TURKEY POINT NUCLEAR GENERATING UNIT NO. 3

TURKEY POINT NUCLEAR GENERATING UNIT NO. 4

ATTACHMENT TO LICENSE AMENDMENTS

SAFETY EVALUATION BY THE OFFICE OF NUCLEAR REACTOR REGULATION

Figure 3.2-3a

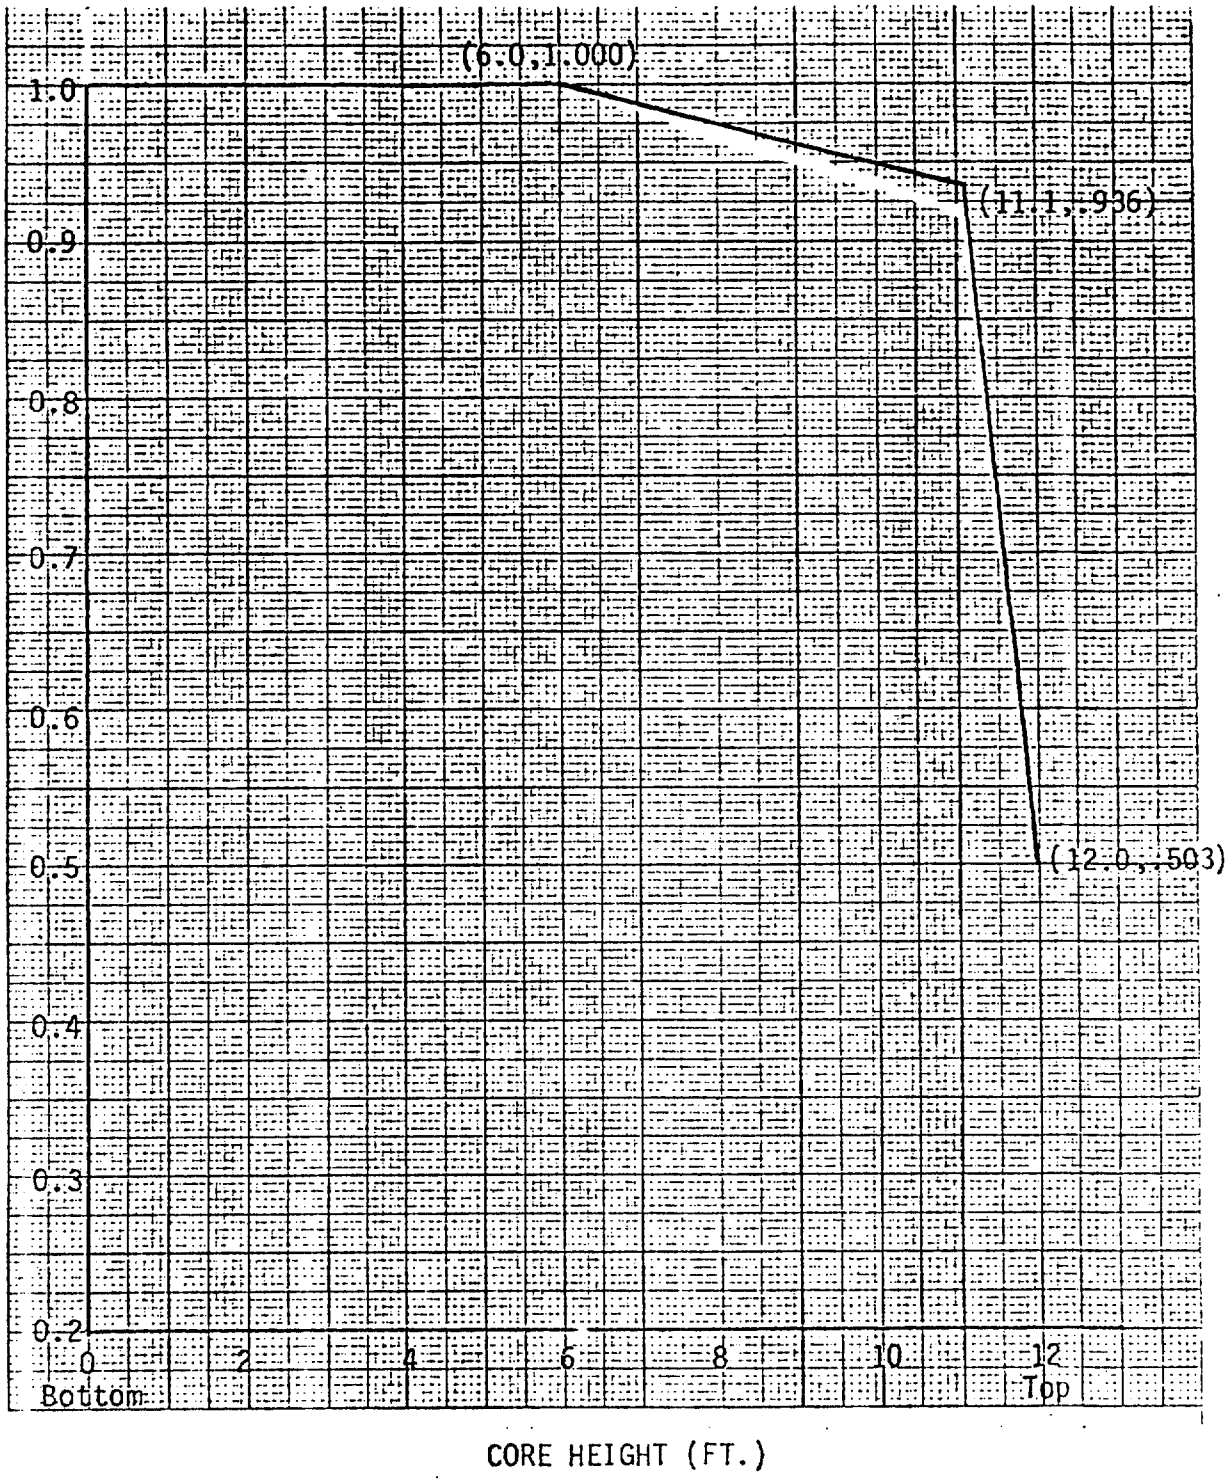
Where P is the fraction of rated power at which the core is operating; K(Z) is the function given in Figure 3.2-3a; Z is the core height location of F_q.

(b) change of the Hot Channel Factor Normalized Operating Envelope for a steam generator tube plugging limit of 22% (Figure 3.2-3a).

$$F_q(Z) \leq (1.99/P) \times K(Z), \text{ for } P > .5$$

$$F_q(Z) \leq (3.98) \times K(Z), \text{ for } P \leq .5$$

(a) change of F_Q to 1.99 for plant operation with 22% or less of the steam generator tubes plugged.

FIGURE 3.2-3b

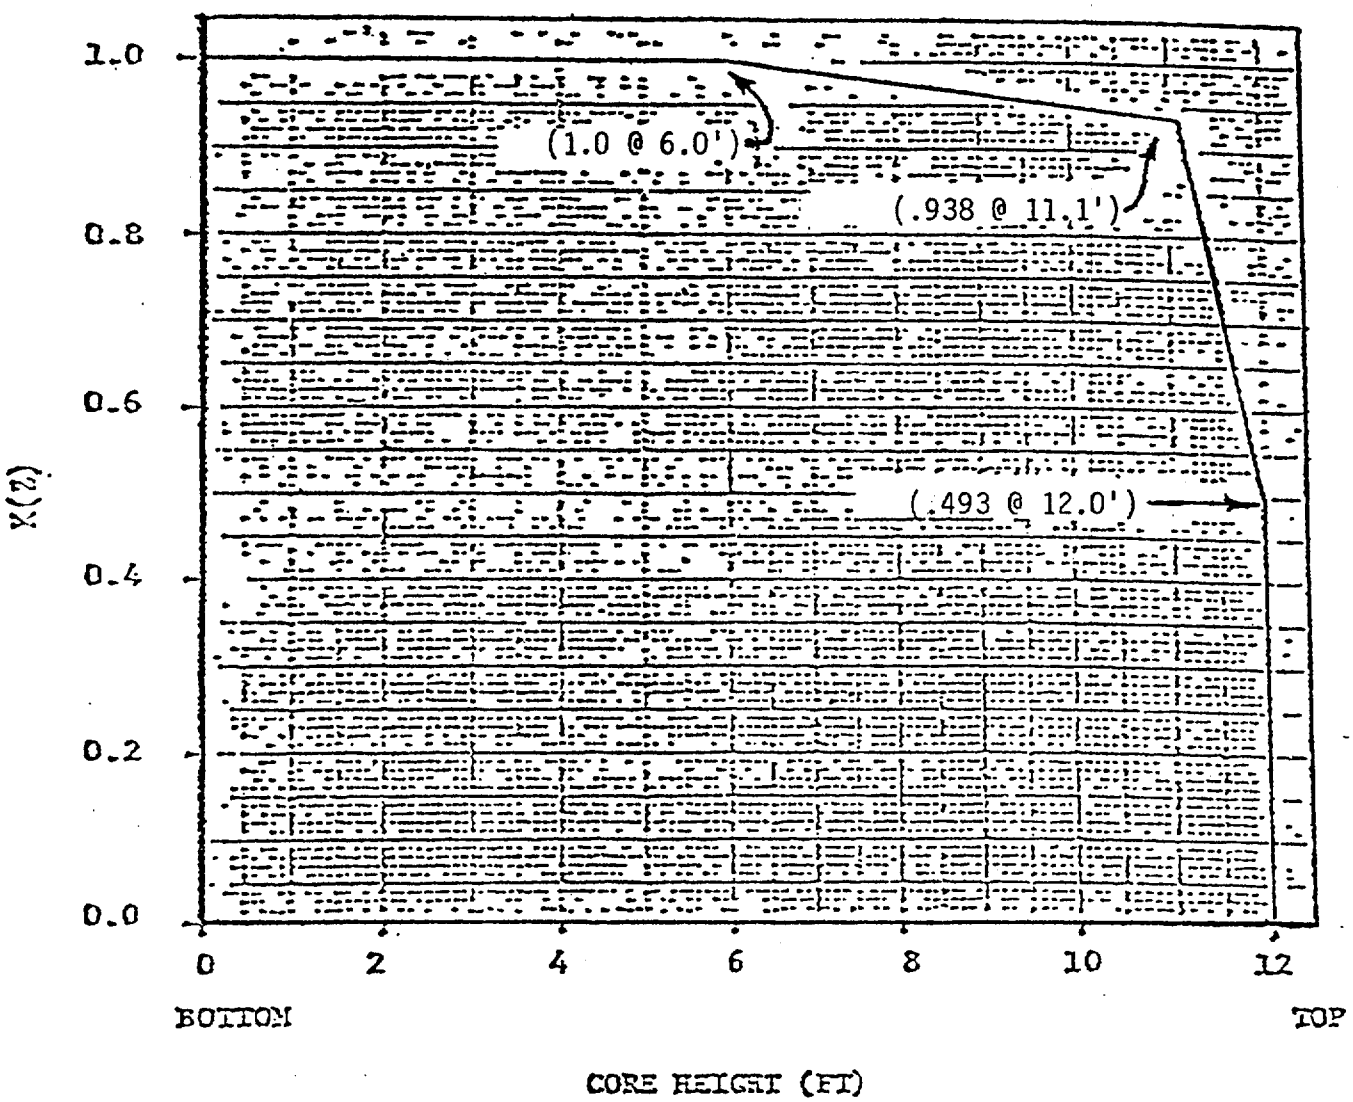
Where P is the fraction of rated power at which the core is operating; K(Z) is the function given in Figure 3.2-3b; Z is the core height location of F_q.

* To be supplied based on results of revised ECCS analysis for 25% steam generator tube plugging. Pending NRC approval of this analysis based on a 25% plugging limit, a 22% tube plugging limit shall be in force.

* To be supplied based on results of revised ECCS analysis for 25% steam generator tube plugging.
